Questions from Chair McMahon with responses from Staff in red.

Docket Item #16 DSUP #2025-10001 2601 Cameron Street

Re: George Mason Elementary School Tree Removal summary analysis: 2601 Cameron Mills Road
IMEG# 24005288

Sincerely,

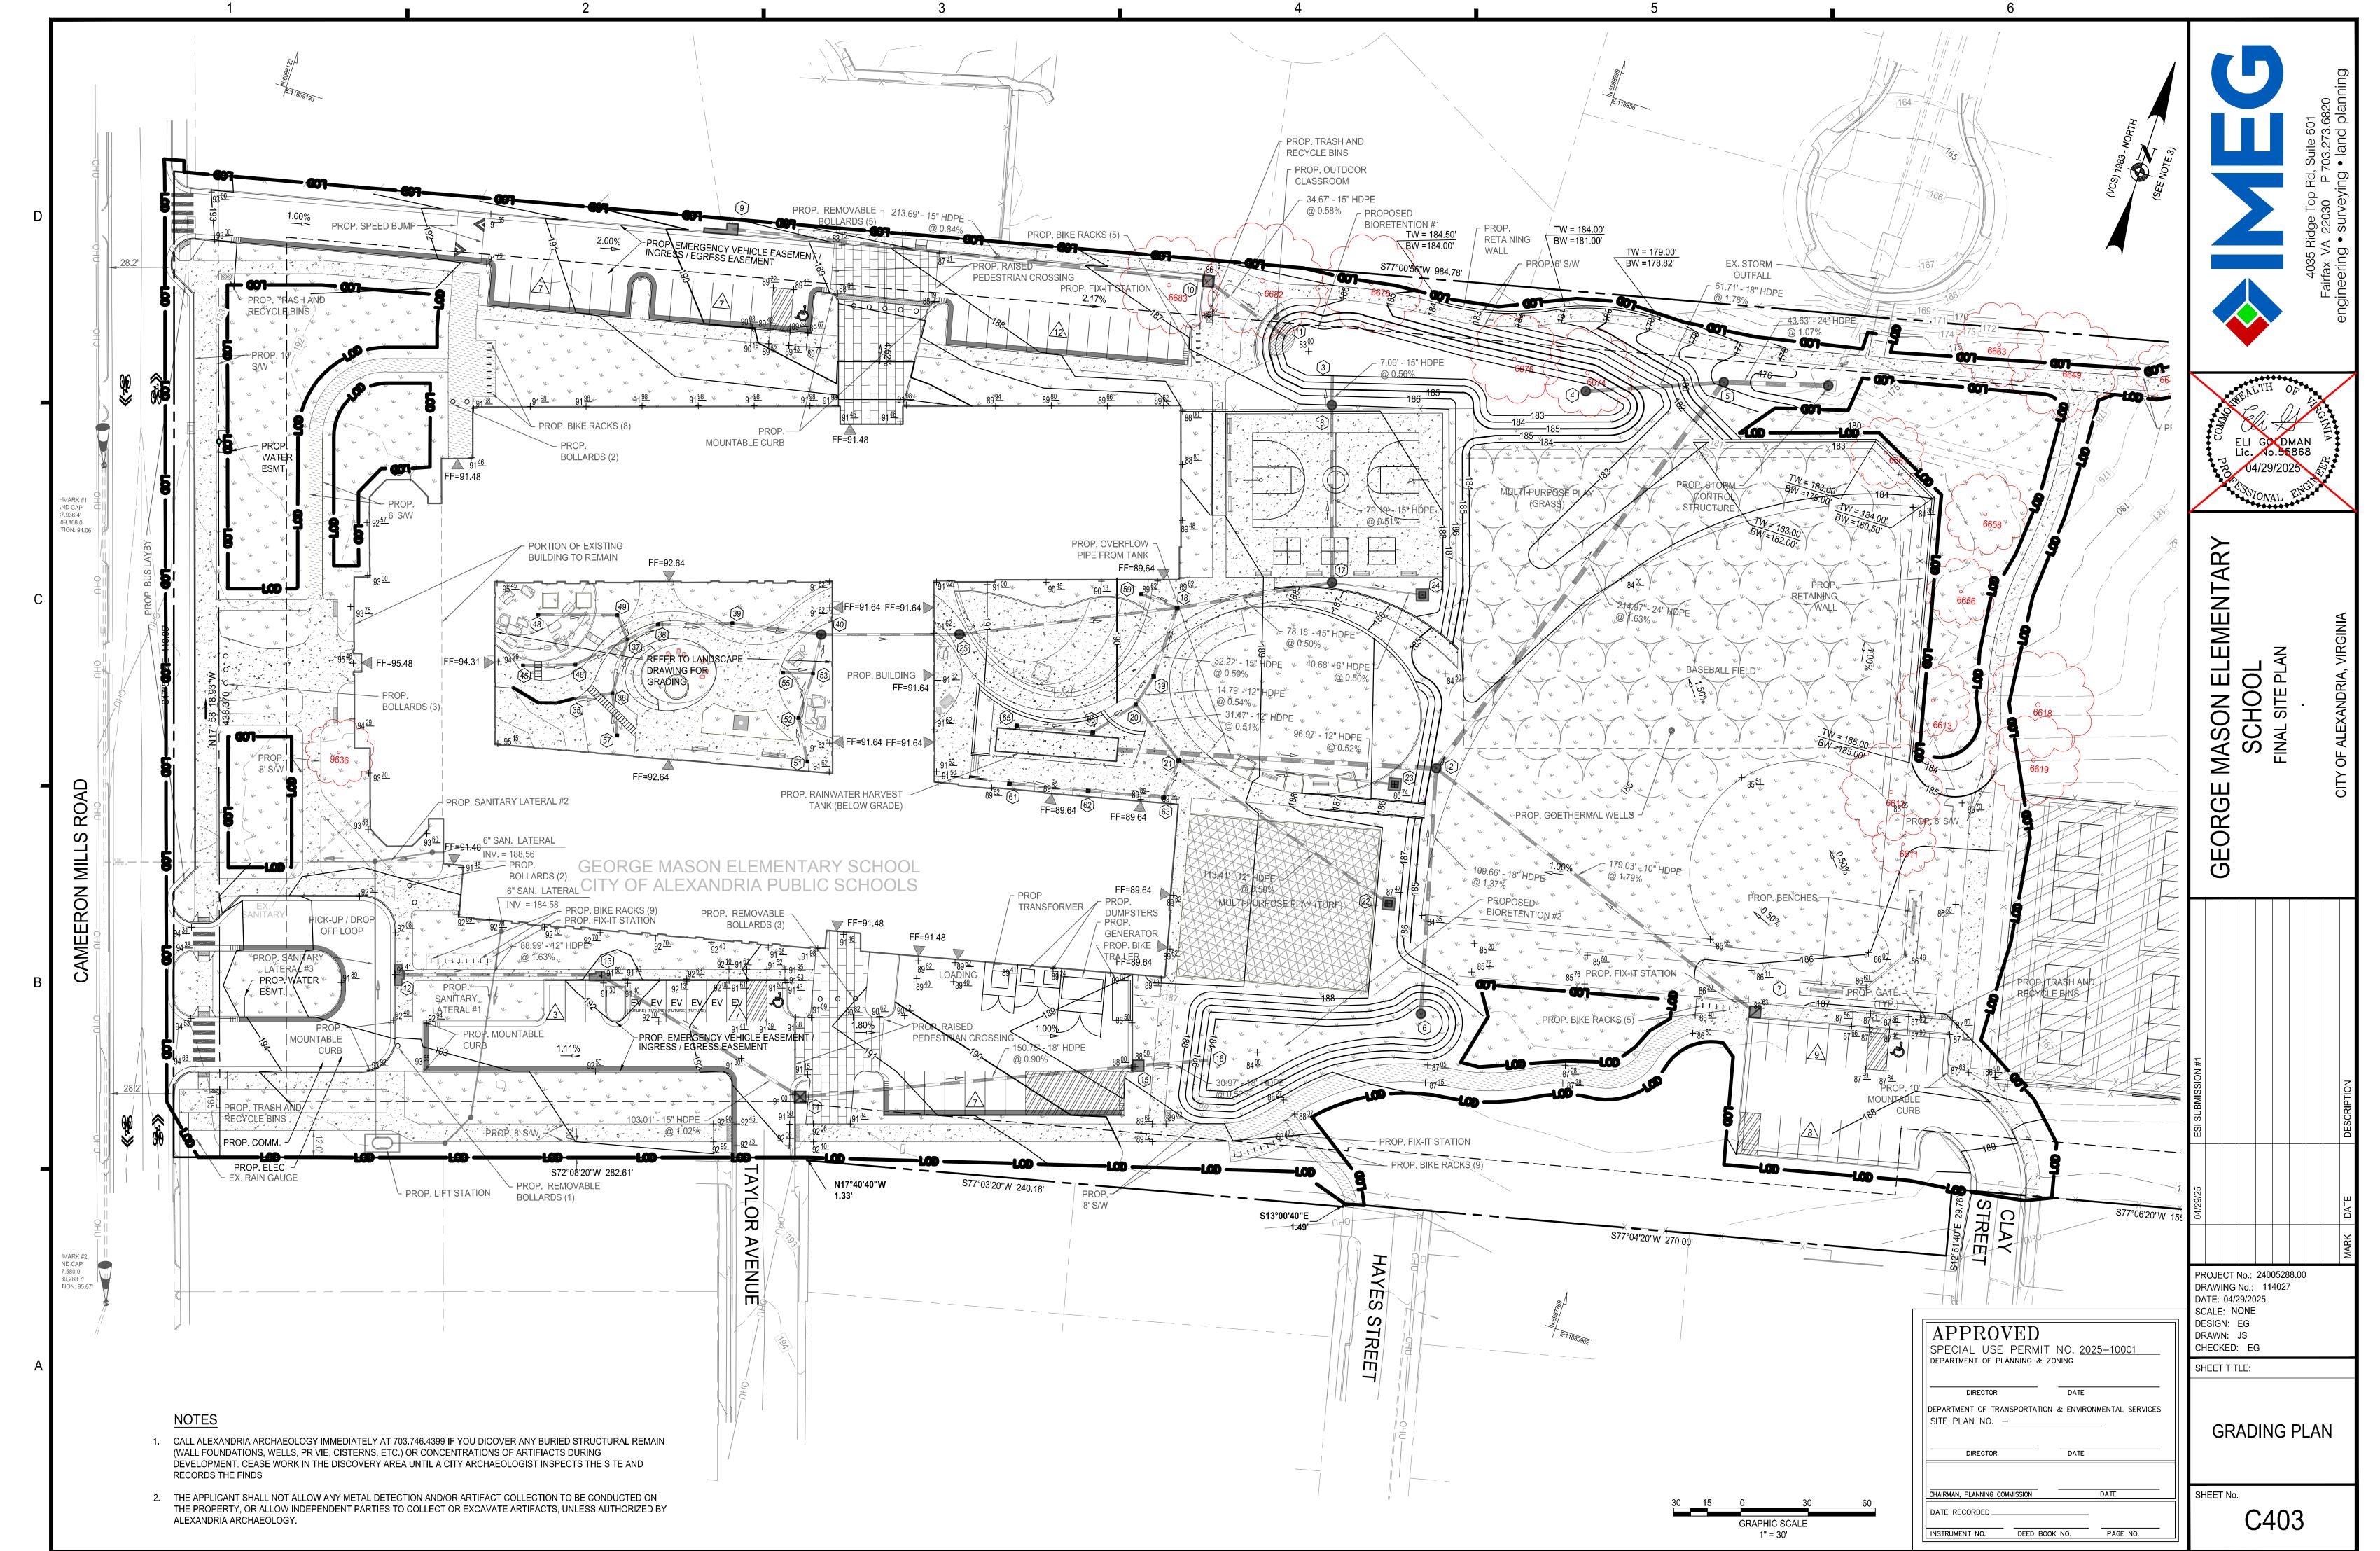
Proposed Tree Removal analysis:

- 12 of the Identified trees in question (#9636, #6683, #6682, #6678, #6674, #6661,# 6649, #6648, #6644, #6612, and #6661) as seen on the associated GMES Tree Mark up 2025-05-01, are located inside the Limits of disturbance. This means that these trees will experience 100% CRZ and SRZ disturbance due to grading, internal road improvements, increased parking, storm water management improvements, installation of geothermal wells, and park pathway improvements. The level of disturbance these trees will experience is not survivable and they will need to be removed

- Tree # 6613 is 28" White Oak (Quercus Alba). Tree 6613 is proposed to be removed due to the level
 disturbance of its root zone from proposed grading and the installation of geothermal wells on the eastern
 half of the property. These site improvements are calculated to remove 58% of the CRZ and 25% of SRZ.
 Even with tree protection measures, such as tree protection fencing or root pruning, the level of impact to
 the CRZ and SRZ is so severe that tree #6613 would not survive the development and should be removed.

- Tree # 6618 is a 45" Black Oak (Quercus Velutina). Tree #6618 is proposed to be removed due to the level of disturbance to it's CRZ and SRZ from the pathway improvements on the western side of the property. The removal of the existing pathway as well as the regrading and installation of the new pathway would remove 44% of Tree #6618's CRZ and 20% of it's SRZ. Even with protection measures, such as tree

- Tree# 6619 is a 36" Black Oak (Quercus Velutina). Tree #6619 is proposed to be removed due to the high level of disturbance to it's CRZ and SRZ from the park pathway improvement on the eastern side of the property. The removal of the existing pathway as well as the regrading and installation of the new pathway would remove 43% of tree #6619's CRZ and 27% of it's SRZ. Even with tree protection measures, such as tree protection fencing or root pruning, the level of impact to the CRZ and SRZ is so severe that tree #6619 would not survive and should be removed.

- Tree # 6656 is a 24" Black Oak (Quercus Velutina). This tree is in very poor condition with a condition rating of 53, as noted on Tree schedule of the GMES Tree and Vegetation protection plan. This rating is due to poor trunk structure from a very heavy lean towards the existing baseball field, as well as approximately half of the crown being dead, and there being a visible pocket of decay/ heart rot present in the upper trunk. Since this tree is located in a park next to a public athletic field and is currently in poor condition, I would recommend this tree to be removed regardless of development impact because it is currently a hazard. However, in addition to tree #6656's poor condition, 32% of the trees CRZ will be removed due to grading improvements and the installation of the geothermal wells to the east and park pathway improvements to the west. Due to the poor existing condition and the sever impact to the CRZ from site improvements this tree should be removed.

- Tree #6658 is a 32" White Oak (Quercus Alba). Tree #6658 is proposed to be removed due to the high level of disturbance to the CRZ due to grading improvements and the installation of the geothermal wells on east side of the tree and the park pathway improvements to the west. These improvements are proposed to remove 45% of the trees CRZ. This is well above the 30% disturbance threshold and this level of disturbance to the CRZ is so severe that tree #6658 would not survive the development and should be removed.

- Tree #6663 is 34" Pignut Hickory (Carya Glabra). Tree #6663 is proposed to be removed due to a high level of disturbance to it's CRZ and SRZ from the park pathway improvements on the western side of the property. The removal of the existing pathway as well as the regrading and installation of the new pathway would remove 42% of it's CRZ and 26% of it's SRZ. Even with tree protection measures, such as tree protection fencing or root pruning, the level of impact to the CRZ and SRZ is so severe that Tree #6618 would not survive the development and should be removed.
